### **DESIGN RESPONSE CONFERENCE**

**File No:** DRC12-00001  
**Project Name:** Transit Oriented Development at South Kirkland Park and Ride  
**Applicant:** Polygon NW  
**Project Planner:** Janice Coogan, Senior Planner  
**Date:** March 26, 2012  
**Meeting Date and Place:** 7:00 p.m., April 2, 2012  
City Hall Council Chambers  
123 5<sup>th</sup> Avenue, Kirkland

Re: Design Response Conference for the proposed Transit Oriented Development at the South Kirkland Park and Ride, File No. DRC12-00001

KIRKLAND TOD | SOUTH ELEVATION

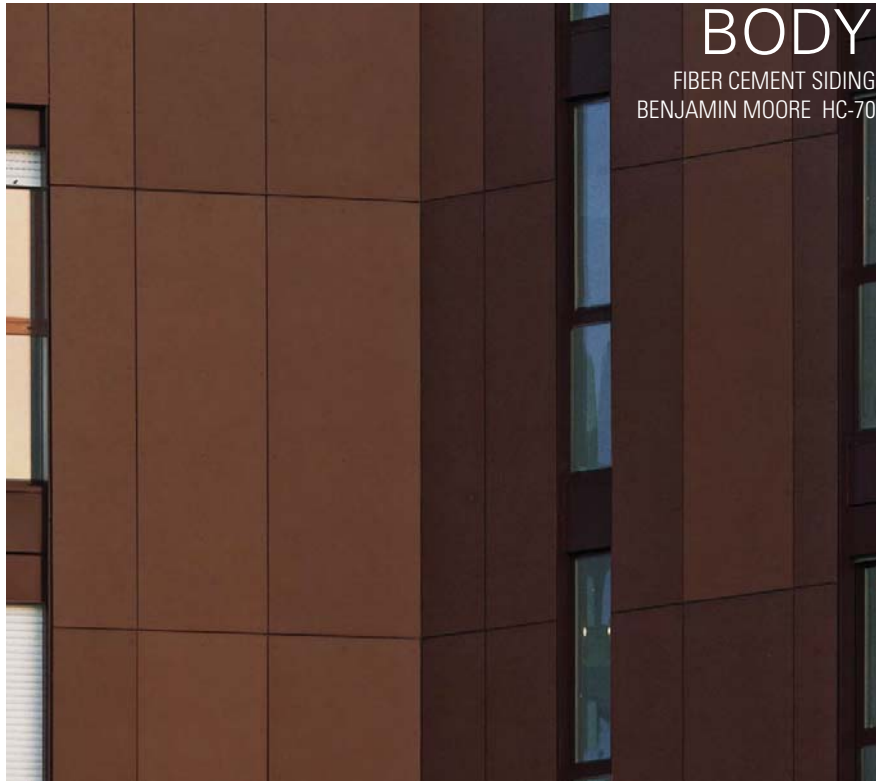
For the Imagine Housing building, the focus of the discussion was on the façade facing NE 38<sup>th</sup> PI. The applicant provided three design options for changing the middle portion of the building. With one exception, the DRB agreed with the applicant's preferred design option which includes a block of bay windows with an area for a vertical sign. The Board liked the two toned paint color with the lighter color on the top fourth level shown in Option 1 and requested the applicant to consider making that change. The Board wanted to know the size of façade panels for the bays at the next meeting.

The board supports the architect's preferred option for the buildings showing the one column of bay windows and vertical sign, except they like the two toned color scheme in Option 1 with the lighter color of paint at the top level.

Attachment 3 incorporates the applicant's preferred design and the DRB comments for the Imagine Housing façade including the three toned bay windows in lighter colored panels, the lighter band of color at the top level, darker paint in the middle section, vertical signage and board formed textured concrete for the base and landscaping along the street. The revised plans call out the building materials and colors including the use of a vertical wood panel system for the elevator/stair tower along the sides of the building to the rooftop terrace.

*Design Team Response: A revised elevation based on the board's recommendation will be submitted under separate cover.*

# MIDBLOCK PEDESTRIAN PLAZA

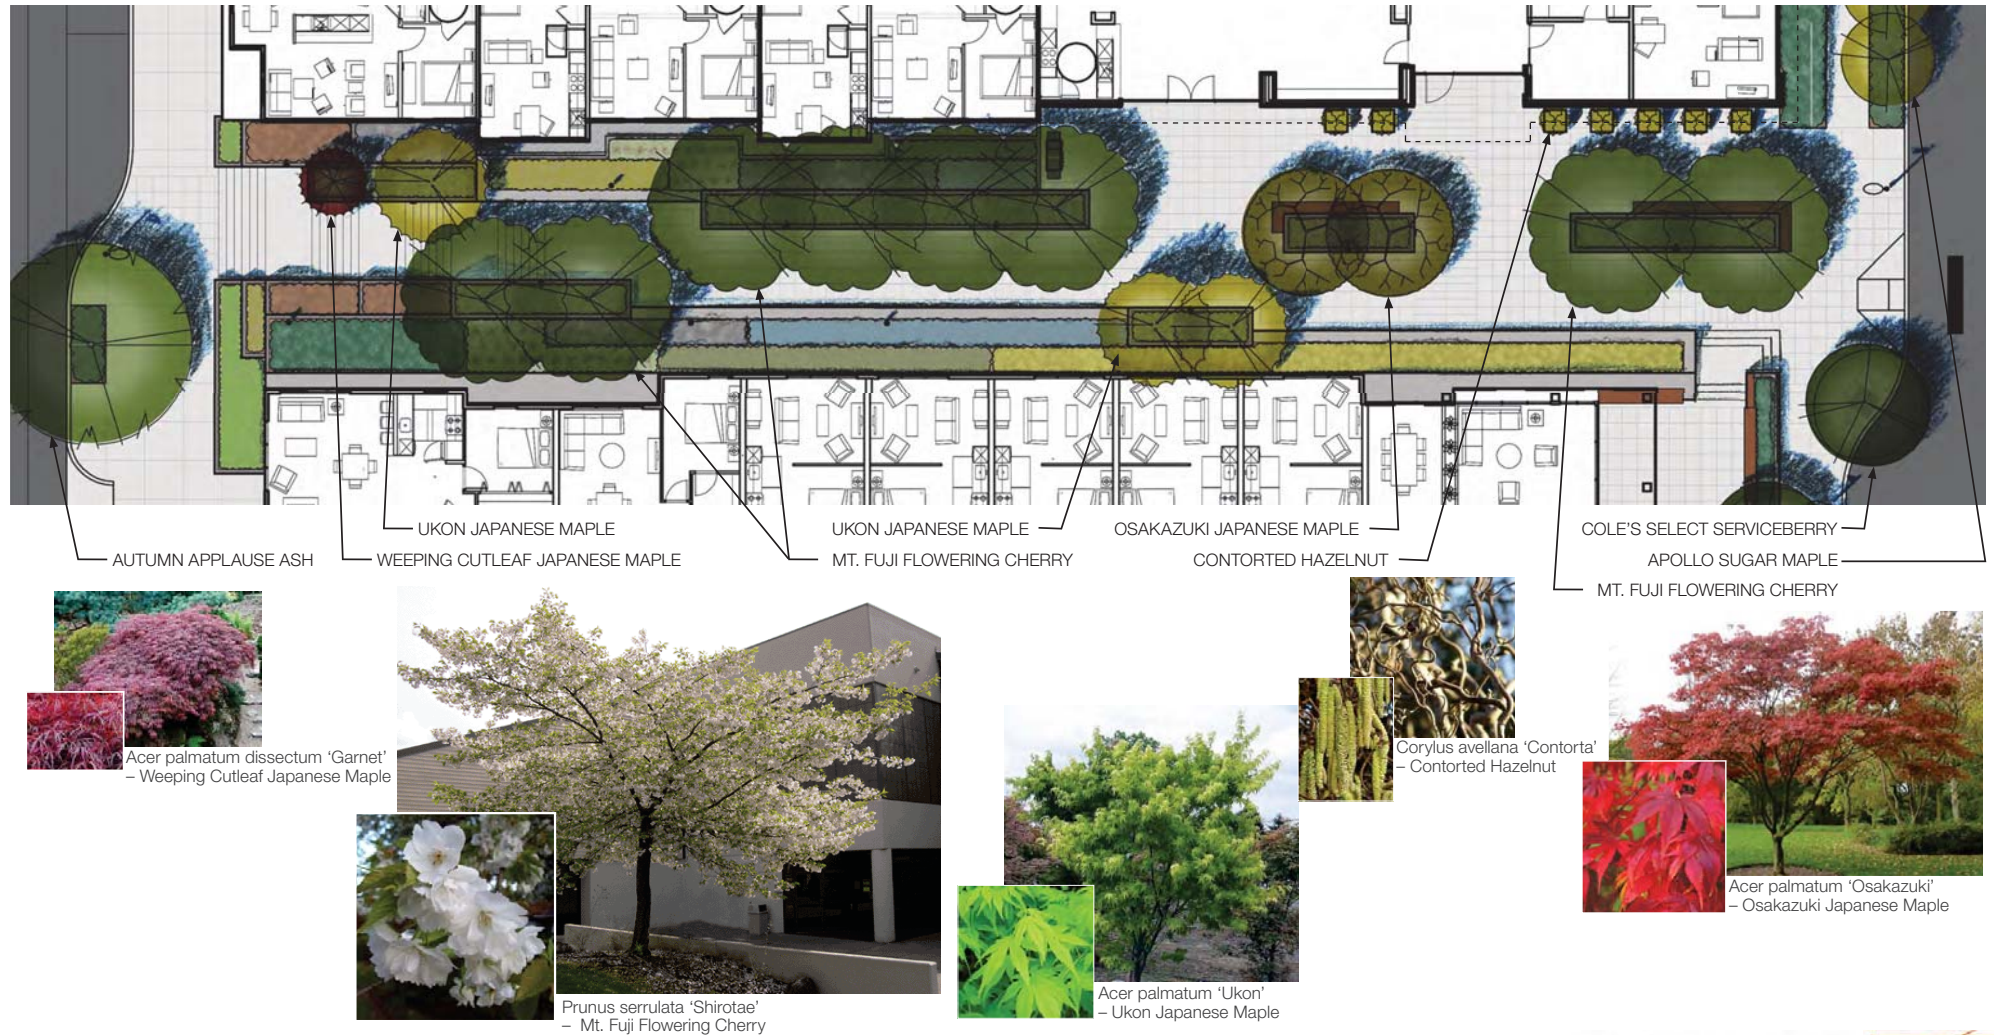
The DRB requested refined details about the design for the through block pathway regarding materials, and landscaping.

Attachment 3 provides greater detail of the through block pathway including use of:

- Combination of two feet by 2 feet square precast concrete pedestal pavers and 1 foot x 4 foot precast concrete accent pavers
- Wood benches and concrete seat walls along side landscape planters
- Combination of pedestrian lights, bollards and step lighting
- A palette of trees and seasonal foliage for color, texture, flowers and fragrance.

F52-FRAME

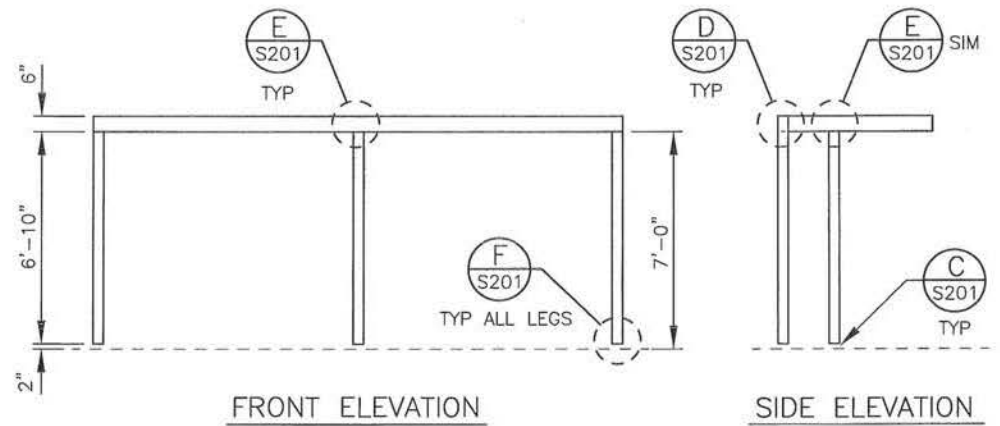
The DRB had concerns whether the two bus shelters shown on the plans are adequate for the amount of transit riders and if there were other options for the design of the shelters. The Board requested information from METRO regarding what types of furniture and bus shelters are prescribed vs what flexibility there is in the design for the transit center. King County Metro Transit should indicate if they support the current design for the transit center.

The Board would like to hear from King County Metro how flexible they are with the design for the bus shelters and other public furniture and if they are in support of what is designed. What other options are there? Could an overhead canopy be used instead of the shelters? They also expressed concern that two shelters are not adequate for the amount of transit riders.

- Two transit shelters are proposed at the two bus stops along the 12' wide loading island (currently there are 3 smaller ones).
- The transit shelter design is shown on Attachment 2 (last page) with an elevation of the shelter Frame F52 which is approximately 7' tall x 17' long x 5' wide.
- No additional funding is available to upgrade the design. The garage elevator lobby and canopy will provide an additional 20'x30' passenger waiting area.

Design Team Response: King County Metro has reviewed and approved the proposed fixture style and locations which rely on their standard specification of furnishings. King County Metro does not have any additional funding for upgrades to the standard furnishings. The furnishings proposed are preferred both from a replacement and maintenance standpoint as they are standards throughout their facilities and promote ease of maintenance. The shelters were specifically selected for their ability to fit within the 12' loading island, maintain bus mirror clearance, and allow additional trees to screen the facility from the adjacent residential units. The shelters shown on the site plan are the F-52 Metro shelter model as indicated in the cut sheet included with the submittal exhibits. The two bus stops each have a 5'x17' shelter. The current bus loading has 3 smaller shelters of a different standard Metro style. In addition to the shelters the garage elevator lobby and its entry canopy provide an additional 20'x30' passenger overflow waiting area.
